# 802.3dj D1.3 Comment Resolution Common Track

Matt Brown (Alphawave Semi), 802.3dj Chief Editor Leon Bruckman, Nvidia Jeff Slavick, Broadcom Adee Ran, Cisco

- This slide package was assembled by the 802.3dj editorial team to provide background and detailed resolutions to aid in comment resolution.
- Specifically, these slides are for the various common track comments.

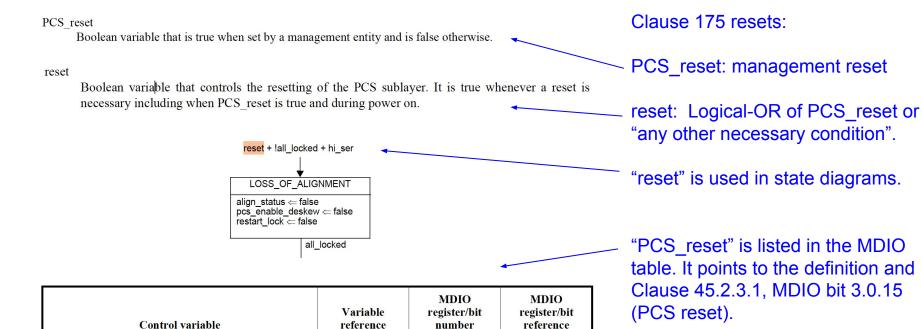
FEC reset is referred to in the definition of the "reset" variable, but FEC reset is not defined except through a cross-reference to 45.2.1.1.1. The MDIO control variables table (Table 184-4) already has a cross reference to 184.6.2.2 as well as CL 45 and the MDIO register bit number,

Remove the cross-reference text "(see 45.2.1.1.1)" from the definition of reset in 184.6.2.2.

Add the definition of "FEC reset" to the list of variables in 184.6.2.2 as: "Boolean variable that is true when set by a management entity and is false otherwise".

PROPOSED ACCEPT IN PRINCIPLE.

Editorial slides with topic "Reset variable" are provided in the following contribution:

## Reset variables (background #2 - CL 176)

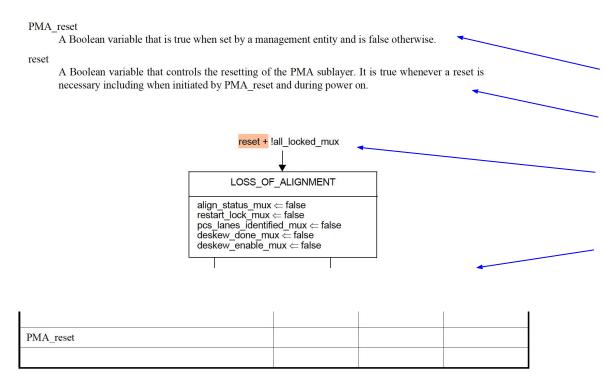
Clause 176 resets:

PMA\_reset: management reset

reset: Logical-OR of PMA\_reset or "any other necessary condition".

"PMA\_reset" is listed in the MDIO table but MDIO table is not yet complete. Should be updated to point to the definition and 45.2.1.1, MDIO register bit 1.0.15 (PMA/PMD reset).

## Reset variables - Comment 88, Clause 177

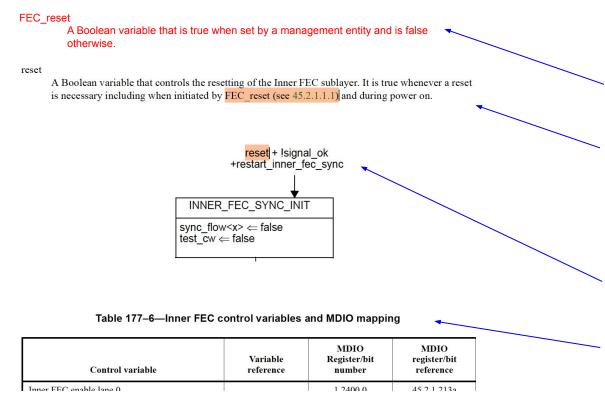
Clause 177 resets:

FEC\_reset: Definition is missing. It should be added to 177.6.2.1.

reset: Uses FEC\_reset. The cross-reference to CL 45 can be removed since the new convention is to reference CL 45 in the MDIO table.

"FEC\_reset" is not listed in the MDIO table and should be added to point to its definition and 45.2.1.1, MDIO register bit 1.0.15 (PMA/PMD reset).

Table 184-4—Inner FEC control variables and MDIO mapping

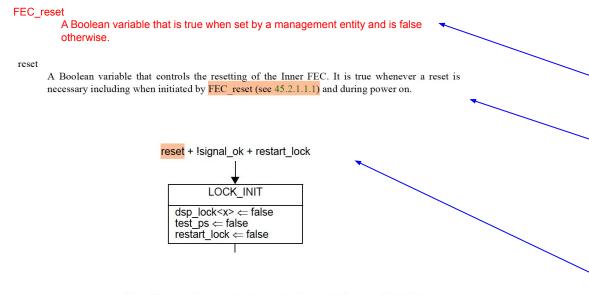
Clause 184 resets:

FEC\_reset: Definition is missing. It should be added to 184.6.2.2.

reset: Uses FEC\_reset. The cross-reference to CL 45 can be removed since the new convention is to reference CL 45 in the MDIO table.

"FEC\_reset" is already listed in the MDIO table. No change needed to the table or references.

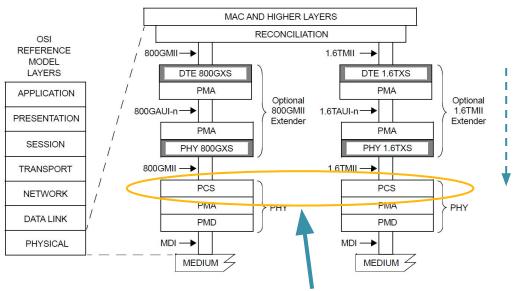
"other" interface is a bit ambigous and the listed situations are the typical use case but does not cover all use cases. As a remote PCS (after a XS) could do either local or clock forwarding modes.

Rename client is pcs to be "uses local clock only" and update the definition to be "Boolean variable that indicates if the PMA will never swap to a forwarded clock. For example this will be true for the first PMA below the RS."

Replace both uses of client is pcs with uses local clock only in Fig 178B-7

- The name of the variable should be a description of the effect, rather than an (incorrect) assumption of when it is set.
- Rename client\_is\_pcs to uses\_recovered\_clock
- Makes adjustments in the state diagram (logic inversion)

- ACCEPT IN PRINCIPLE
- Rename "client\_is\_pcs" to "uses\_recovered\_clock" (logic inverse) and update the definition to be "Boolean variable set to true to indicate that the AUI component or PMD uses a clock recovered from another interface to drive its output when tx\_mode = data. Otherwise it is set to false."
- In Figure 178B-7 change:
  - "client\_is\_pcs" to "!uses\_recovered\_clock"
  - and "!client\_is\_pcs" to "uses\_recovered\_clock"
- Add MDIO variable to configure uses\_recovered\_clock

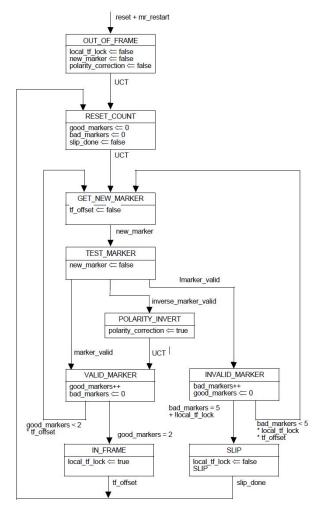
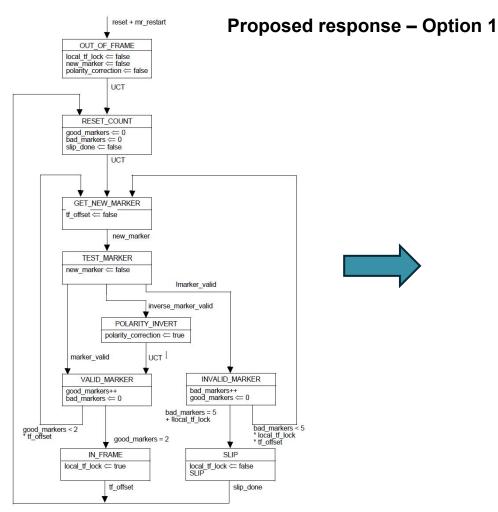
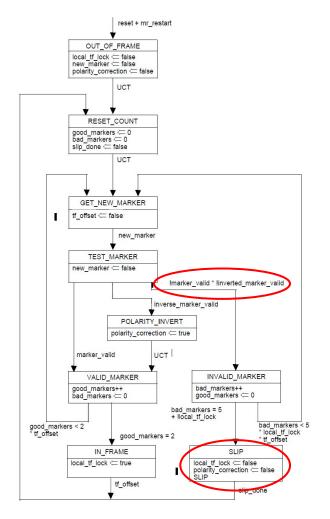
Fig 178B-9 needs to clarify the transitions out of TEST MARKER.

Change the transition from TEST\_MARKER to INVALID\_MARKER to be "(!valid\_marker \* !inverse valid marker) + (polarity correction \* inverse valid marker)"

Change the transition from TEST\_MARKER to POLARITY\_INVERT to be "!polarity correction \* inverse marker valid"

- ACCEPT IN PRINCIPLE
- Replace Figure 178B-9 with the right figure in slide 3 of bruckman\_dj\_03\_01\_20\_2025
- In 178B.10 page 779 line 44 (Polarity detection and correction):
  - Change: "If polarity\_correction is true, the lane input shall be corrected"
  - To: "If polarity\_correction is true and local\_tf\_lock is true, the lane input shall be corrected"
  - Change: "The state of the polarity\_correction variable persists until training restarts."
  - To: "The state of the polarity\_correction variable persists after training completes, correcting the polarity of the data received when tx\_mode is set to DATA."

- ACCEPT IN PRINCIPLE
- Replace Figure 178B-9 with the right figure in slide 5 of bruckman\_dj\_03\_01\_20\_2025
- In 178B.14.3 page 786 line 35 (polarity\_correction definition):
  - Change: "Boolean variable that is set to true when an inverted marker is detected. Otherwise it is set to false."
  - To: "Boolean variable that is set to true when inverted markers are detected upon acquiring training frame lock. Otherwise it is set to false."
- In 178B.10 page 779 line 43 (Polarity detection and correction):
  - Change: "The state of the polarity\_correction variable persists until training restarts."
  - To: "The state of the polarity\_correction variable persists after training completes, correcting the polarity of the data received when tx\_mode is set to DATA."
